Mrs. [REDACTED] [REDACTED] Residence  
[REDACTED] Beach, Florida  
Installation Verification Inspection  
FINAL – 3-25-22

**Re: Installation Verification and Testing Structural Glazing Assessment**

TSSA Project # [REDACTED] - Installation Verification/Testing [REDACTED]  
[REDACTED] Beach - 2022-2-23

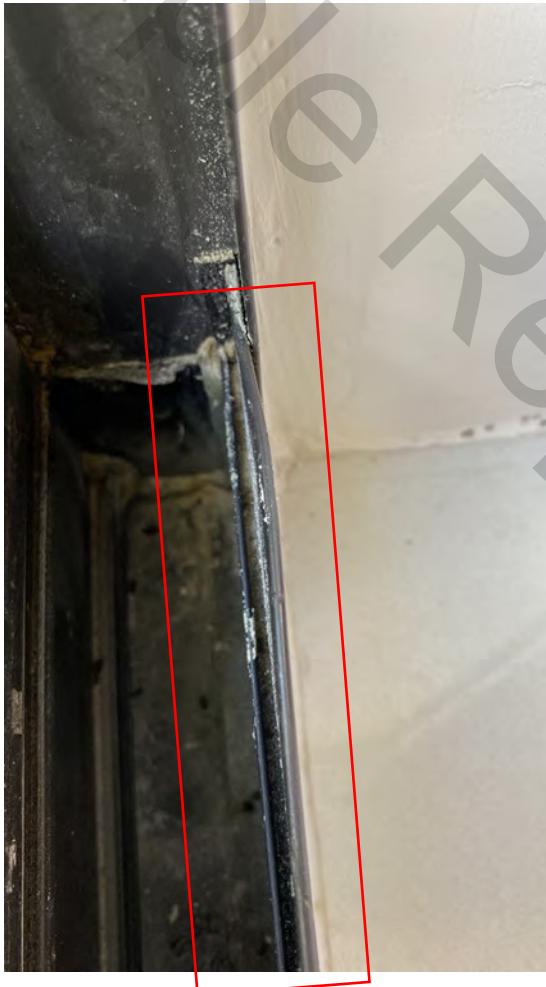
8. Window was installed over old stucco, and new stucco was installed after window was installed. As a result, the primary seal between the window and the old stucco was not adhering upon inspection.

Sealant Adhesion Failure on both the Exterior Stucco and the aluminum frame.

As stucco is a Cementous material, proper cleaning was not performed, leaving excessive Granular residue on the original stucco finish. This Granular Residue did not allow the sealant used during the installation of the window systems to form a proper adhesion bond between the installed window system's frame and the pre-existing stucco. Due to this fact, the primary seal (first point of contact between the window system and the host structure) was never correctly set.

If the primary seal is not set, the window is not seated correctly in the Rough Opening. This is a significant cause of water infiltration between the window frame and the stucco exterior.

1. Remove windows completely and clean all existing sealant and caulk from the frame.
2. When windows are out – use a wire roller or brush to clean all existing paint residue down to bear stucco
3. Prepare Masonry Opening with liquid applied flashing as per the recommendation of AAMA Best Practices.
4. Install Code-approved pressure-treated bucking that will support the new frame as per Florida Building Code.
5. Cut out Plaster return – to allow the proper installation of shims.
6. Re-install window as per NOA
7. Complete Exterior and Interior Sealing

26

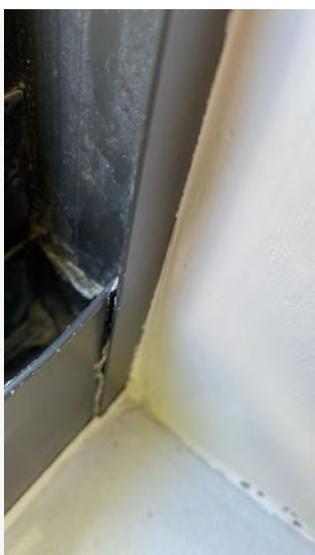
Sill Riser is bent and separated from its installed positions

Sealant Disruption is witnessed at the sill riser to jamb connection point

27

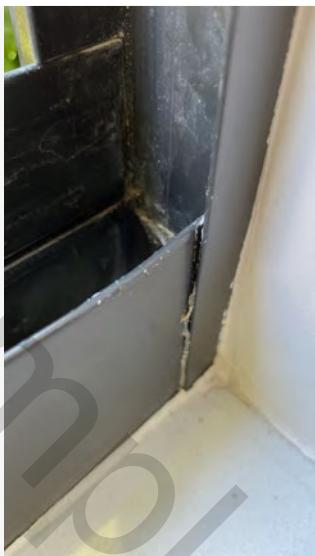
Sill Riser is bent and separated from its installed positions

Sealant Disruption is witnessed at the sill riser to jamb connection point

48

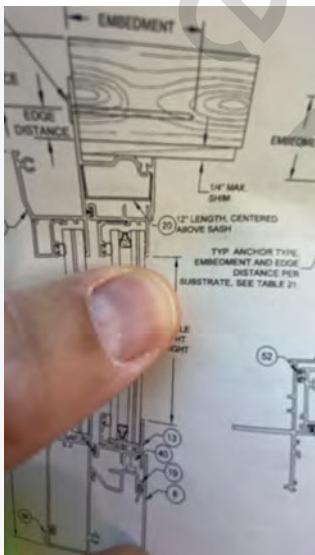
inspection shows that no bucking was used and the frame is not completely supported  
No Shims were witnessed

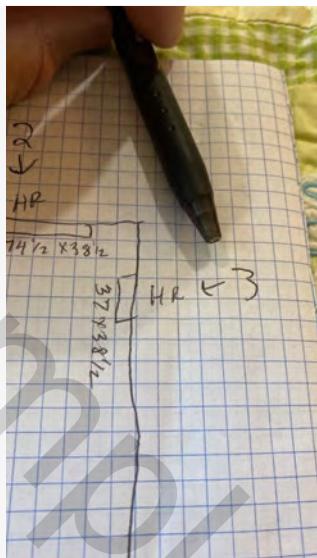
Sealant Adhesion Failure on both the Exterior Stucco as well as the aluminum frame

35

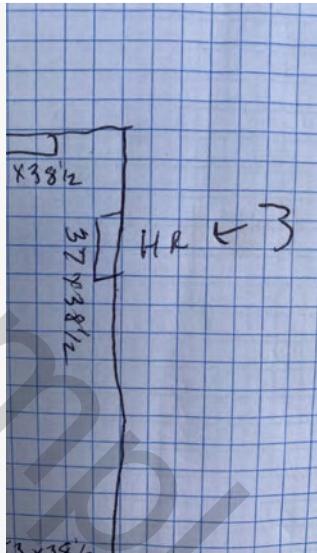
Sill Riser is bent and shows signs of being hammered back into position. This damage is due to manipulating the frame into position during the installation

Sill Riser is bent and shows signs of being hammered back into position. This damage is due to manipulating the frame into position during the installation

27

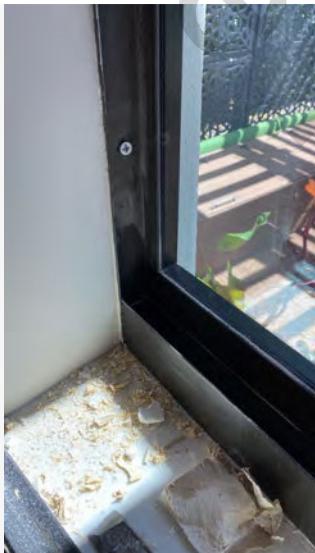
Sealant Disruption is witnessed at the sill riser to jamb connection point  
Sill Riser is bent and shows signs of being hammered back into position.

7

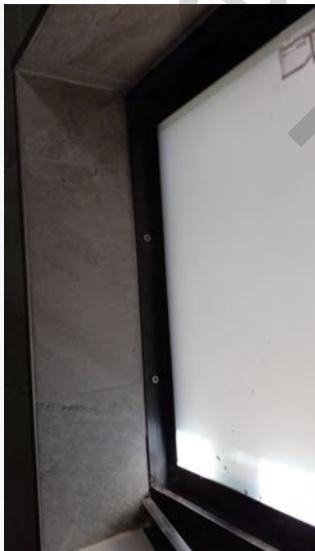
Fasteners not fully seated

9

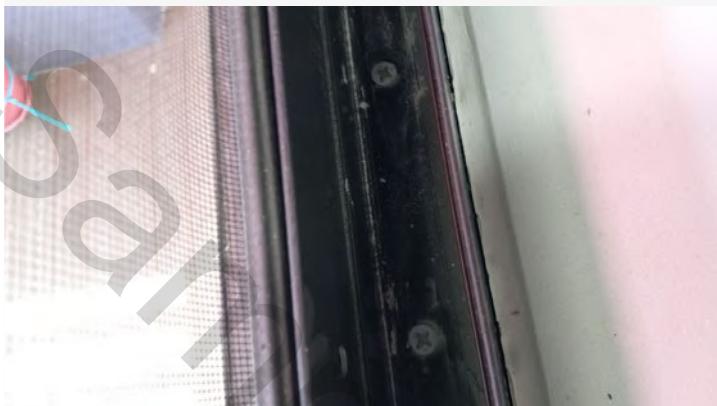
Sill Fastener Head appears to be covered with a hard dense plastic material not specified sealant as per best practices

Weeping system was rendered un-functional from the interior of the sill track with Cementous material

5

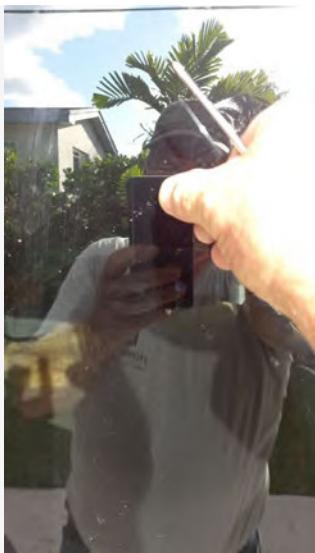
Glass stop disruption caused be frame bowing

Frame was Torqued due to no Shims being used to the point of effecting the glazing leg pulling the frame member away from the installed glass lite.

Frame Bowing visually evident.

4

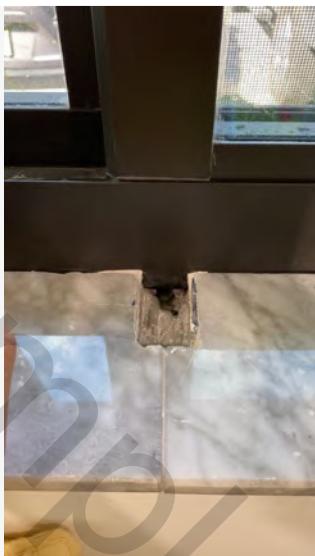
A notch in the Marble Sill from previously installed Mull Bar allowed for a visual inspection under the sill.  
No wood was witnessed under the sill of the new system.

## hinge inspection

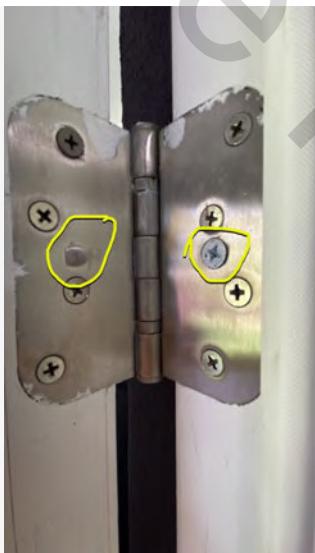
installer added a screw into the anti-break in mechanism of the hinge  
door is now warped toward the striker plate by approx. 3/16 in
